Securing the Antenna Unit's Bottom Cover

Artemis MK5 Engineering Note EN5-15

Photo 1

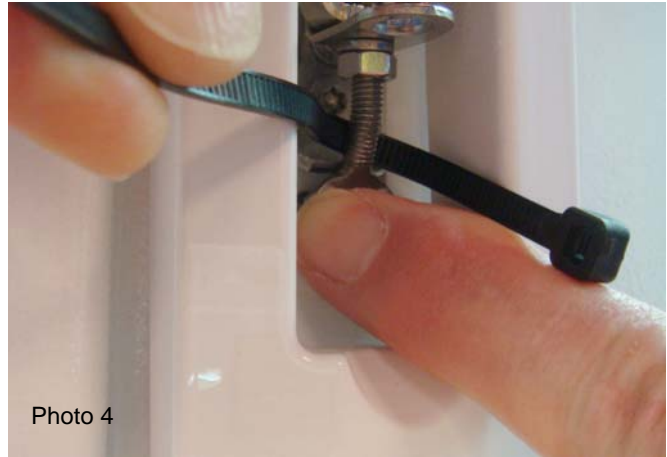
Reports from the field have reached us in which it is reported that severe weather conditions, e.g., heavy waves splashing against the Artemis station, may cause the snap locks with which the Bottom Cover is fastened to the Artemis MK5 Antenna Unit to become undone.

To avoid the snap locks becoming undone some years ago already lockable snap locks were fitted to the Artemis Antenna Unit. The eyelet of this type of snap lock offers the possibility to secure the snap locks by inserting for example a pad lock, a cable tie, a stainless steel M6 socket-head bolt with spring washer and nut (photo 1) or a snap harness (photo 2). The latter has the advantage that no tools are required to remove it, but has the disadvantage that it may damage the paint.

With new delivered Artemis MK5 stations a set of four stainless steel M6x16 mm securing bolts complete with spring washers and nuts will be supplied. For earlier delivered stations these sets are available from our agent Reson at no charge.
